Urgent Field Safety Notice

Prismaflex Control Unit

FA-2019-050

Device Correction

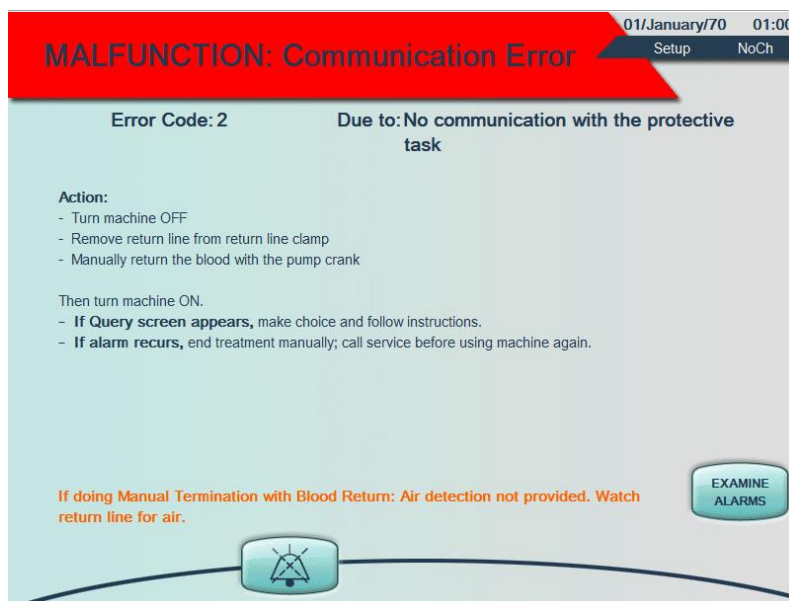
- The Prismaflex control unit enters a “safe state” by stopping all pumps and closing the return line clamp. Treatment is suspended. The patient’s blood does not circulate through the blood flow path.
- Red flashing light
- Recurring high-pitched sound of 10 sound pulses repeated approximately every 8 seconds until muted.
- Malfunction screen appears on the display as pictured below. The instructions to the user are the same for all error codes.

1. Operators may continue to safely use the Prismaflex control units until the upgrade is performed. If a communication error alarm does occur, follow the instructions presented on the graphical user interface and/or in the operator's manual. Please reinforce the importance to manually return the extracorporeal blood to the patient, and re-train users on this process, outlined on page 10:57 (to be adapted locally) of the operator's manual, if necessary.
